## SERVICE BULLETIN

Bulletin No: JC-019-09 REV-1

### REVISED IDLER KIT 970395

## I.S.-970395 LIQUID COOLED PTO IDLER KIT

FIGURE 3

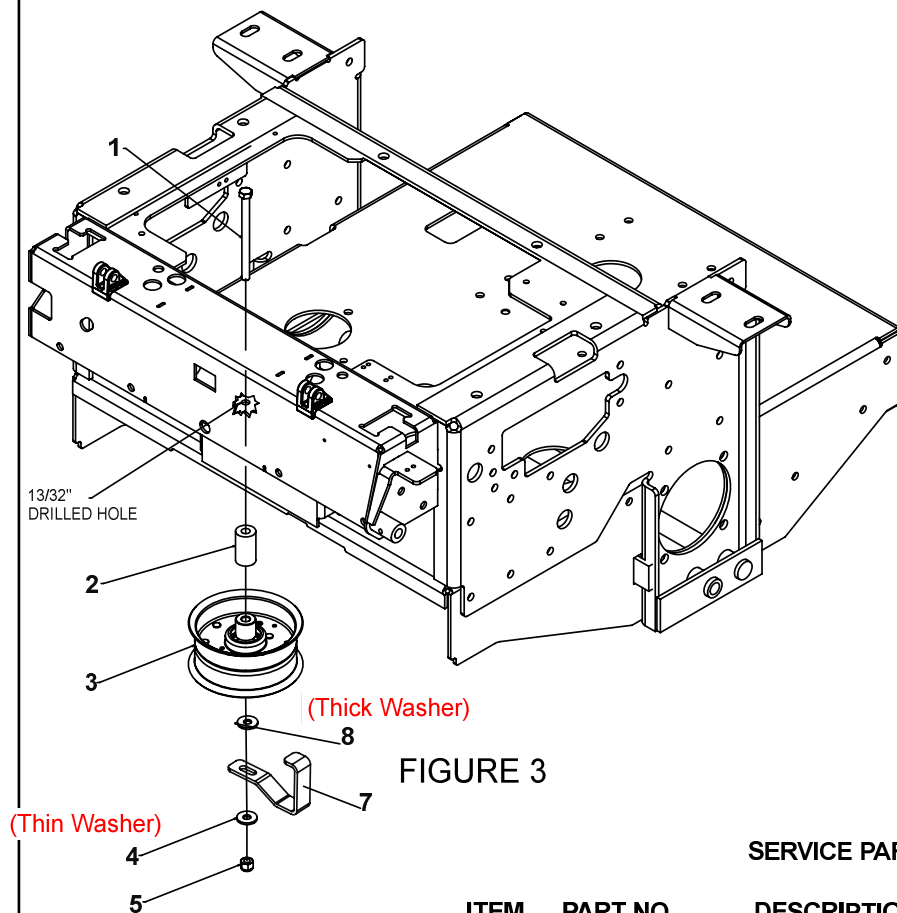
Upon the release of kit 970395, we have found that when cutting conditions are at extremes the belt can climb up on top of the new idler. To be proactive, we have started to include a wrap around guide in kit 970395. We recommend having this guide installed for any units in the field with kit 970395 previously installed.

**Action Required:** If kit 970395 has already been installed, order belt guide **4165330.7** and thick washer **64163-105** and submit warranty. See the attached directions for details on this kit and placement of the guide.

1. Cut out template 4164771 provided with kit.
2. Position the template inside the frame, aligning along the edges as shown in Figure 1 and Figure 2.
3. With the template in position, locate and center punch the drill location.
4. Remove the template and drill a 13/32" hole at the punch location.
5. Assemble the idler as shown in Figure 3.
